Product Change Notification: E-18-000770

PCN Date: 01-FEB-18

General Product Description:
 DEUTSCH HD30 and HDP20 Series, size 18 and 24 Plugs and Receptacles.

HDP24-24-35PE Before Change (Shown as example)

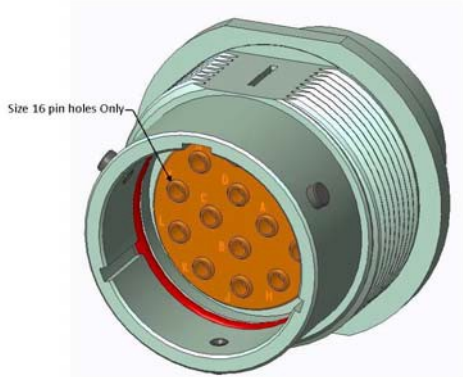
Size 16 pin hole diameter has been reduced.

Product Improvement. Dear customer, in an effort to continuously improve our products, TE-ICT will be reducing the size 16 pin hole diameter to improve alignment robustness. This product change will not impact part fit or function. The form is affected (smaller hole diameters). See photo. You may get mixed shipments. **IMPORTANT:** The current and previous revisions of these parts can be used interchangeably in the field. This change is being phased in gradually and previous revision can remain in stock until use. Product drawings are not affected.
